Access Compliance Report

Public Rights-of-Way (Curb Ramps)

Intersection ID: 14859	Main Street: BRIAR_CREEK_RD	Cross Street: COLONNADE_DR	Location: SW
ADA ID: 6D71D0AEE6EF	Ramp Type: Perp	Initial Pass/Fail: Fail	Overall Compliance: No
Severity Score: 12.5			
Codes/Mitigation Info/Possible Solution		Field Measurements/Component Compliance

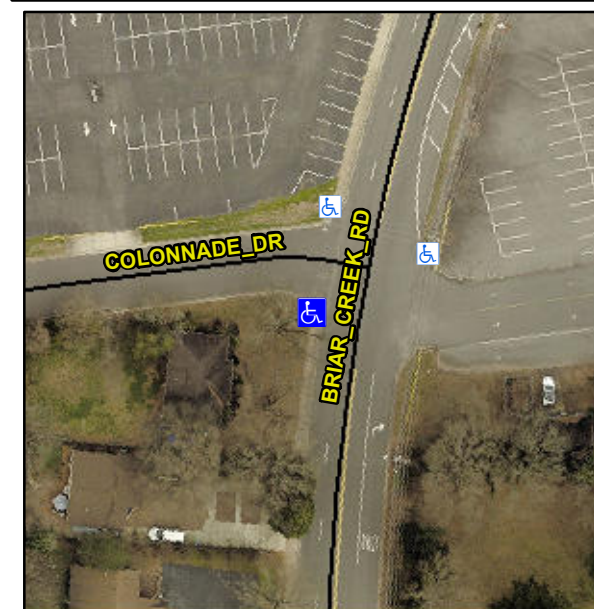
Not Found, R304.2.2

Compliance	Description	Data	Compliance	Description	Data
N/A	Ramp Length (in)	55.0	No	Ramp Slope (%)	11.0
Yes	Ramp Width (in)	49.0	Yes	Ramp XSlope (%)	1.3
N/A	Flare Type LT	N/A	N/A	Flare Type RT	N/A
N/A	Flare Slope LT (%)	N/A	N/A	Flare Slope RT (%)	N/A
N/A	Flare Traversable LT?	N/A	N/A	Flare Traversable RT?	N/A
N/A	Landing Length (in)	N/A	N/A	DWS Provided?	N/A
N/A	Landing Width (in)	N/A	N/A	DWS Contrast?	N/A
N/A	Landing Slope (%)	N/A	N/A	DWS Length (in)	N/A
N/A	Landing X Slope (%)	N/A	N/A	DWS Full Width?	N/A
N/A	Landing Curb? (Y/N)	N/A	N/A	DWS Offset (in)	N/A
N/A	Shared Landing?	N/A			
N/A	Gutter Ponding?	N/A	N/A	Gutter Slope (%)	N/A
N/A	Gutter Lip Ht (in)	0.5	N/A	Gutter X Slope (%)	N/A
N/A	Painted X Walk1?	No	N/A	Painted X Walk2?	N/A
	X Walk 1 Direction	To NE		X Walk 2 Direction	N/A
N/A	X Walk 1 Width (in)	N/A	N/A	X Walk 2 Width (in)	N/A
	X Walk 1 Slope (%)	0.8		X Walk 2 Slope (%)	N/A
	X Walk 1 X Slope (%)	1.9		X Walk 2 X Slope (%)	N/A

Remove & Replace Entire Ramp.
